ADDENDUM NO. FOUR

DATE: September 19, 2025
DEPARTMENT: People and Internal Operations Department (PIOD)
PIOD PROJECT NAME: West Dade Government Center Interior Renovation
Floors 1 through 4
PIOD PROJECT NUMBER: W230030-C
BID DUE DATE: October 1, 2025 (Revised)
CONTRACT COORDINATOR: Marcela Rodriguez

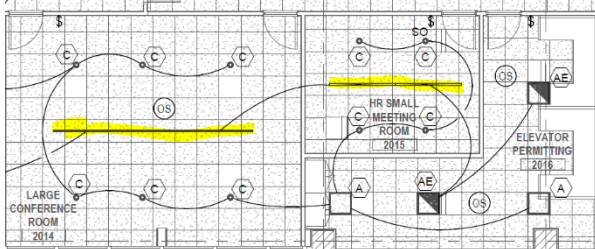
Q119. On Sheet E321.C, there are several lights I'm not sure I should include in my estimate. If you look closely, they're not connected to any circuit, and the area where they're located is marked in gray, which I understand indicates it's not a work area. Could you clarify this?

**A119. Yes, by Contractor.**
